**FEASIBILITY STUDY
SS109 - F-22 WEAPONS RELEASE SHOP**

JOINT BASE ELMENDORF-RICHARDSON, ALASKA

FINAL

Appendix A	Figures
Appendix B	Applicable or Relevant and Appropriate Requirements
Appendix C	Cost Estimates
Appendix D	Responses to Comments

FIGURE NO:
A-4a

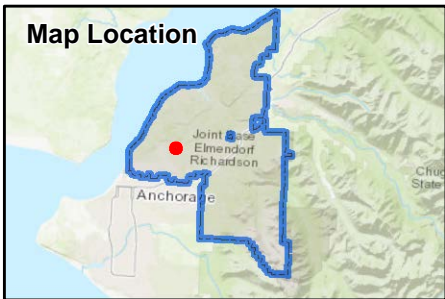
Number	Page	Section	Comment	Response
			This needs to be substantiated better. Fig A-4 displays the SD029 Groundwater plume 400 feet from the inferred soil contamination area associated with SS109. No groundwater contours are provided on Fig A-4; a small blue arrow (in the trees on the SE corner of the map, very hard to see) suggests groundwater flows to the N-NE at this site.	Agree. A figure showing groundwater contours generated using the groundwater elevations measured during the 2016 sampling event will be added to the FS. The purpose of Figure A-4 is to display proposed LUC boundaries that preclude soil excavation relative to contaminated areas and site features.

FIGURE NO:
A-4b

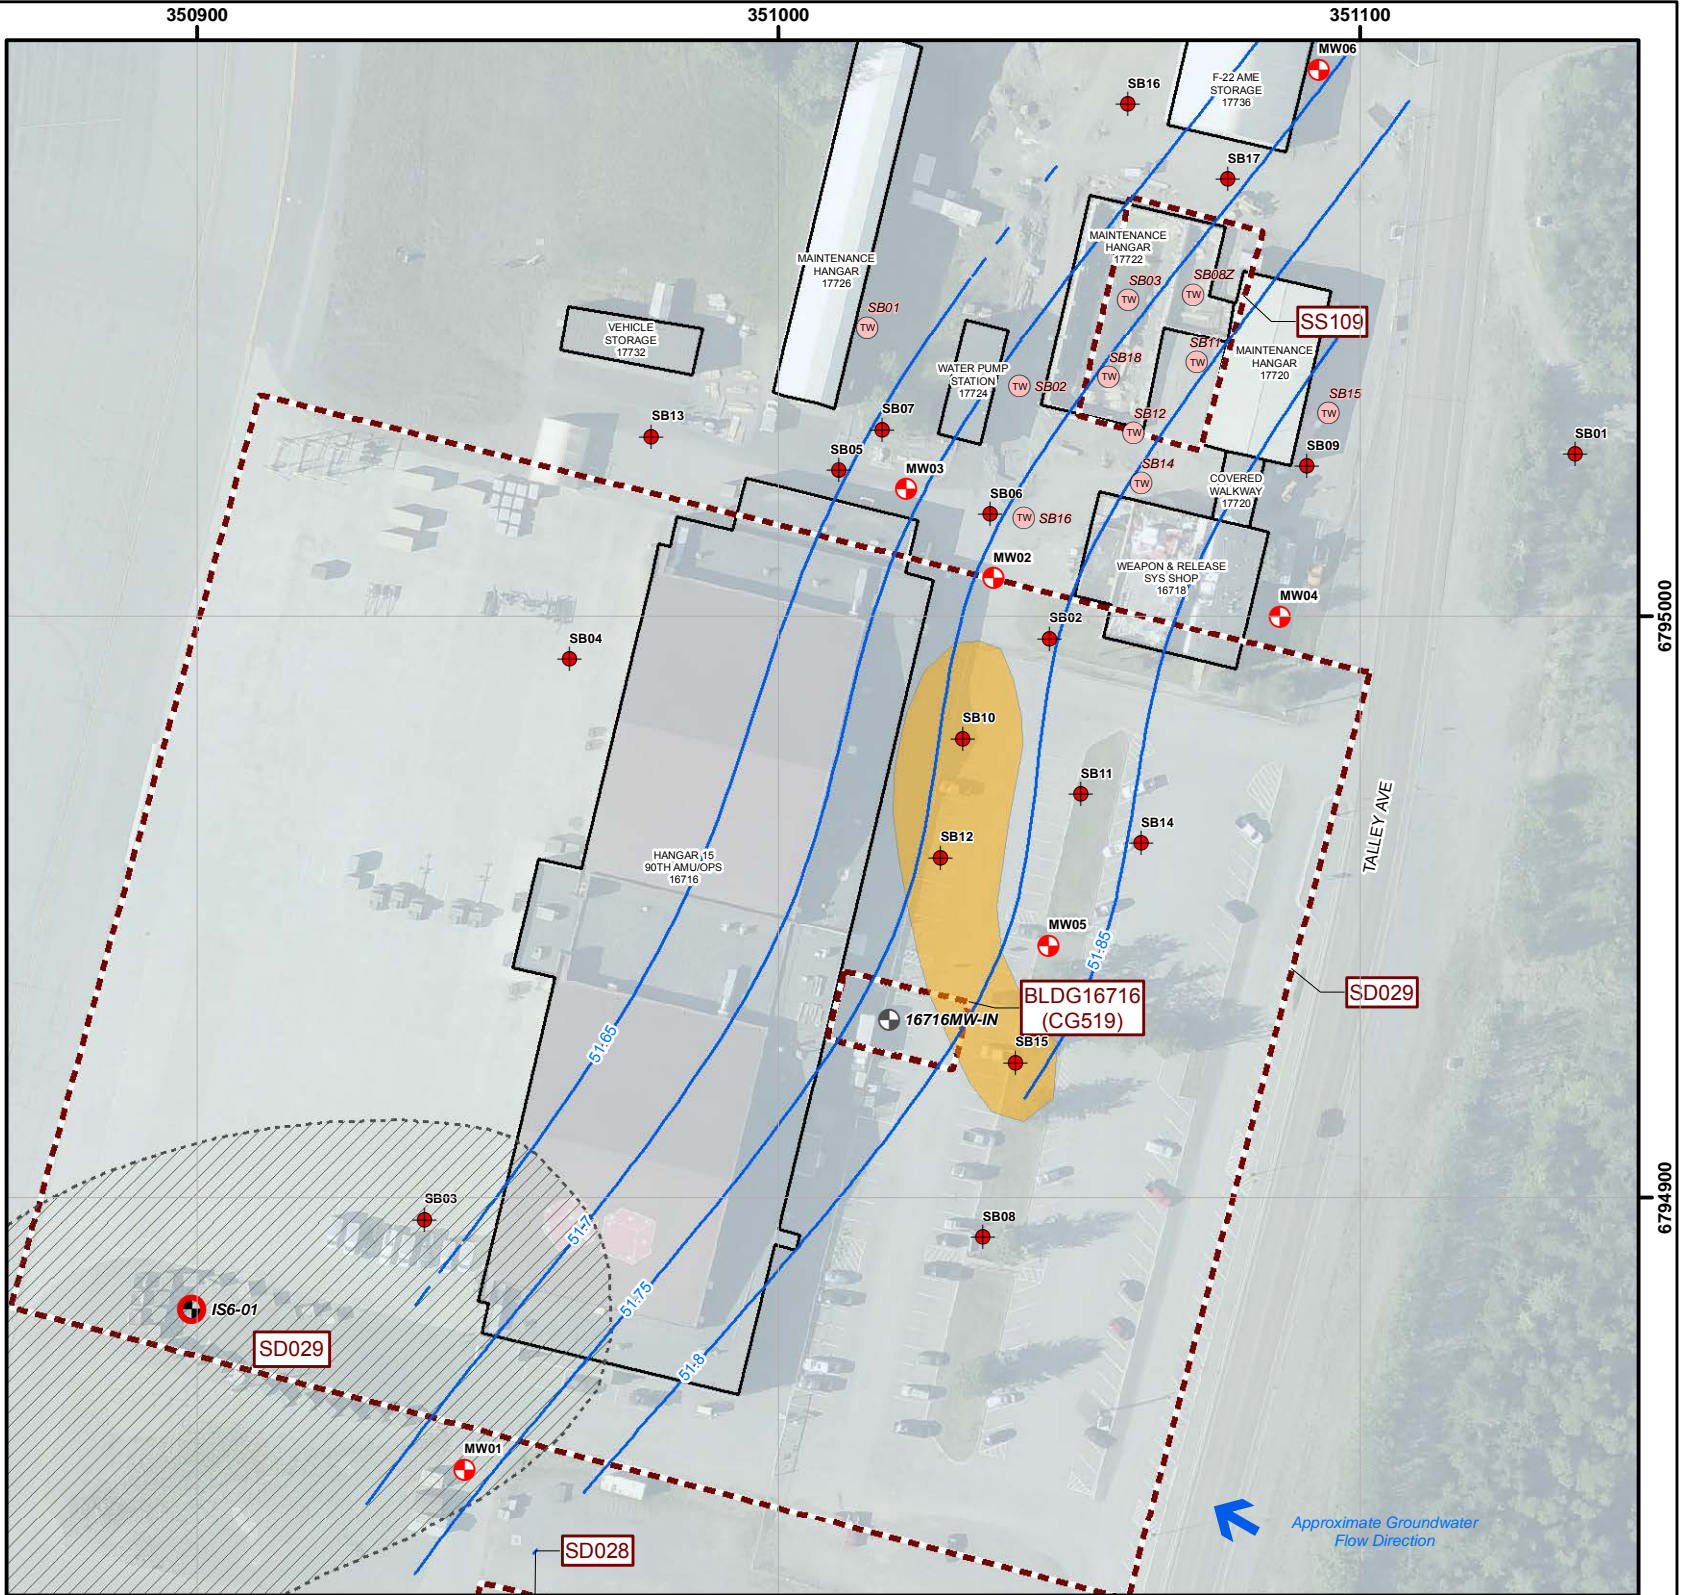
Number	Page	Section	Comment	Response
3.		2.2.6	A figure to present the groundwater results detailed in Section 2.2.6 would be very illustrative.	<p>Agree. Figures showing prior investigation locations for soil and groundwater and PSL exceedances will be added to illustrate the discussion as Figures A-4a and A-4b, respectively. The figure note referencing the RI report will be removed.</p> <p>The soil figure (Figure A-4a) will include the LUC boundary. Note that soil results did not exceed PSLs and no groundwater exceedances are associated with SS109.</p> <p>The following text will be added to the last paragraph in Section 2.2.6:</p> <p>“... separate from the solvent plume associated with SS109. Several sample locations to the south of SS109 show a separation between SS109 and SD029 including SB04, SB08, SB10, SB11, SB12, SB14, SB16, and MW06 (Figure A-4b).”</p>
